Subject: FW: DC/22/93827 Land at Villeneuve St George Way, Eastleigh - landscape comments 9/2/23

Landscape Officer further comments in Green – 9 February 2023

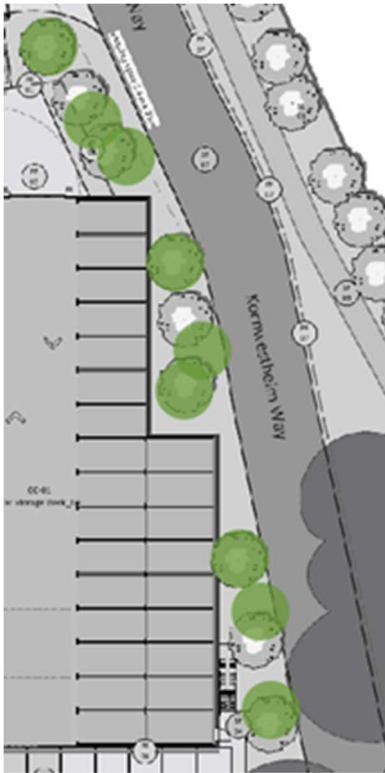
c/ It is disappointing that my earlier comment regarding additional tree planting along the Leigh Road frontage has not yet been accommodated. I can see no good reason why 2 further trees cannot be planted between the totem signs (see extract below). I understand that Hendy may wish for maximum visibility of their new facility, however, this development is at a scale that cannot be missed.

The more easterly totem sign seems excessive, especially as it will be partly hidden behind the existing trees along Leigh Road. Perhaps a single totem sign is sufficient.

Trees should be resisted due to visibility issues with Totems suggest add a group of 3 Amelanchier lamarkii, multi-stemmed, min. 2m to soften the view as Landscape comment E further down

EBC is still of the opinion that the potential for additional trees here is being missed. Please reconsider. Could at least 1 further tree be accommodated? Response acceptable.

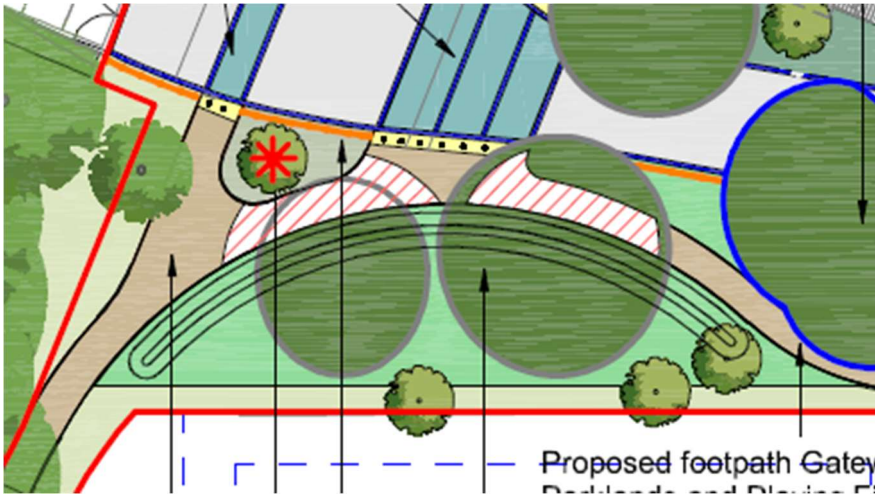
e/ Have any seats and litter bins been considered along the Gateway footpath?

We are not aware of any being specified. We require one bench: Broxap Weburn galvanised and powder coated black 1.8 m long , with arm rests. It should be root fixed onto a rectangular area of tarmac sufficient in size to provide a hard surface beneath and in front where seated people's feet are. Please also provide one waste bin spec below. Locate within the plan shown below. Bench to be to the south of the bund and between the two existing trees. Bin to be to the east of the 'feature' tree, identified by the red asterisk, on the edge of the grass area, where its location will help reduce the length of low railing required. The low railing should be specified through a drawing.

Bin spec:

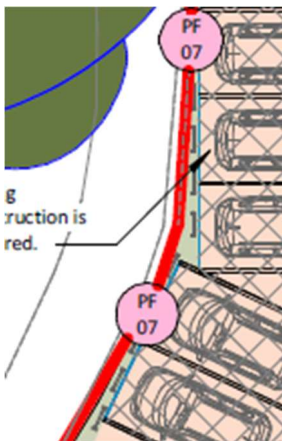
g/ Any thin strips of soft landscape (such as areas below) are too narrow for planting. Please replace with suitable hard landscape alternative.

Agreed these should ideally be stoned or hard paved

Please indicate details on an updated plan.

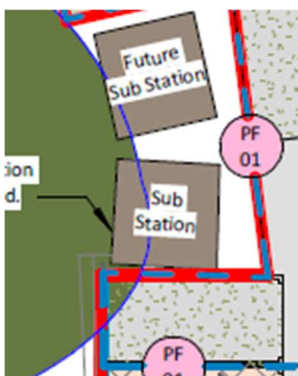
h/ Is there scope to omit this space adjacent the sub stn. and replace with screen planting? It will be a very tight space to access and inaccessible when the gates are open.

Sub. stns. are intrusive in views, so planting here would be welcomed.

Agreed this space is not really useable for cars due to tight dimensions and swing gate operation

This cannot be achieved as access will be required to front of Sub stations

Is there any planting/screening that can be achieved here?

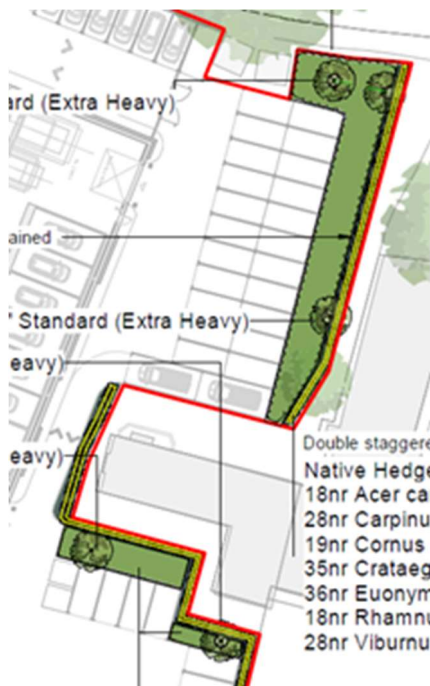
k/ South Boundary Shrub/Feathered trees Mix - is a narrow, informal strip of groundcover required along the back edge of the road? (white flowering Heathers as association with Birch and Pine mix?)

This can be accommodated as requested. This has not been actioned.

Top Soils Plan

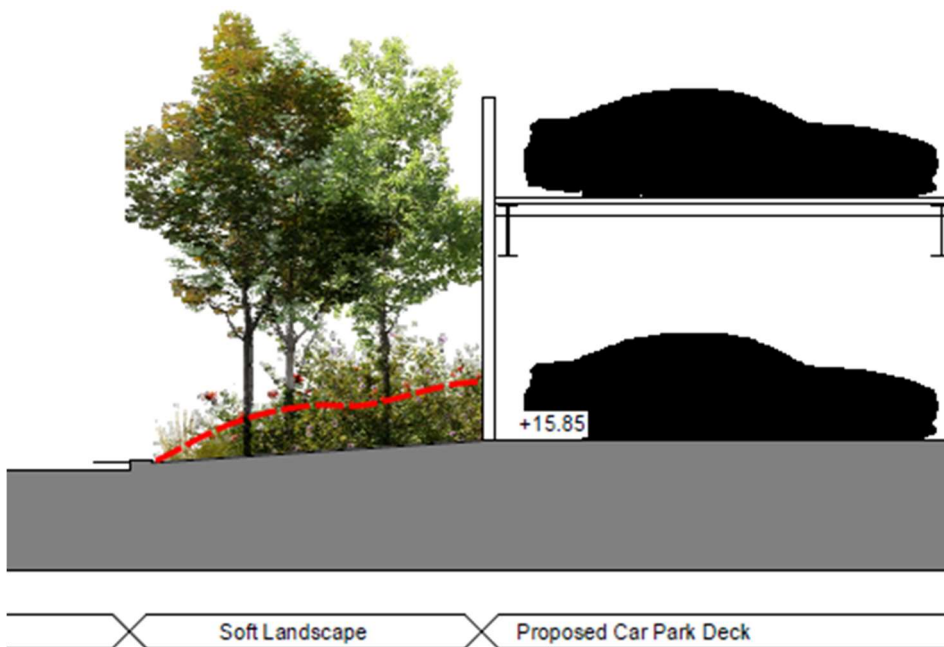
a/ What about ext. hvy. std trees? Also 1:10 compost to topsoil ratio too low. Specify make of peat free compost.

This can be accommodated as requested. The comment that the soil mix is to be specified by a soil specialist is not acceptable on its own. The landscape architect should be qualified to specify this. This information must be included on the plan, whoever specifies it.

Note: 'Selected standard / standard trees to be pit planted, pits backfilled with a mixture of excavated imported topsoil and existing soil, ameliorated with compost to PAS 100 at a rate of 1m³ per 10m³ of soil.'
